Combined License Application for Turkey Point Nuclear Plant, Unit Nos. 6 and 7; Draft Environmental Impact Statement

Document: NRC-2009-0337-DRAFT-0185

Comments on NRC's Draft Environmental Impact Statement for Combined Licenses (COLs) for Turkey Point Nuclear Plant, Units 6 and 7

Turkey Point Nuclear Generating Station

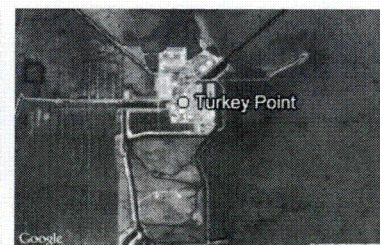
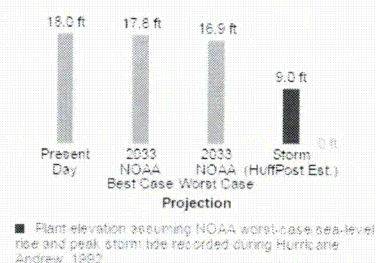
Sadly, the Huffington Post did a better job framing the issue of sea level rise at Turkey point in one graphic than the NRC did in nearly 1500 pages.

Yet NRC's DEIS seemingly fails to address the fact that the Turkey Point site will be an island during a storm surge by the time the proposed reactors would be operation should FP&L ever commit to building them.

Figure 3.2 Water Tower

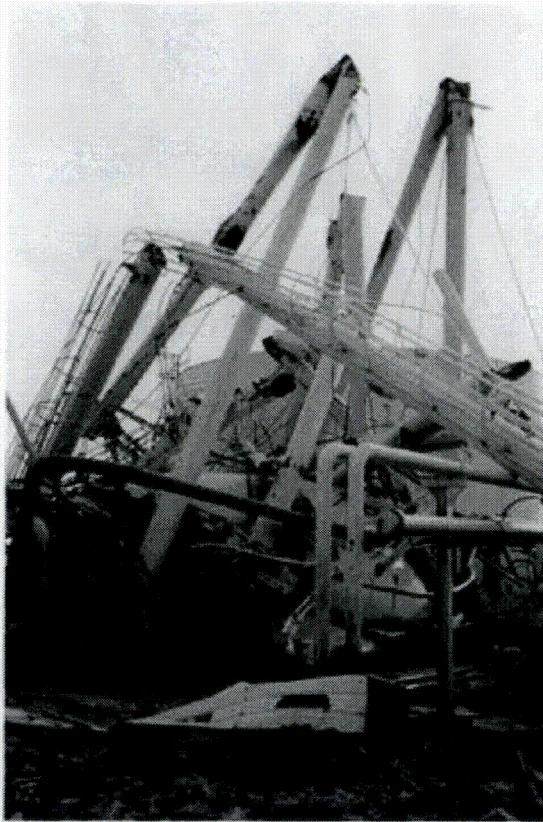
The fire protection system at the plant was disabled when winds knocked a high tower tank onto a 500,000 gallon tank containing water for the fire protection system.... If the damaged stack had fallen, it could have landed on the building housing the emergency diesel generators for the nuclear units. Considering that the diesel generators were the only source of ac power at the plant for several days, it was extremely fortunate that the leaning stack of Turkey Point did not fall.
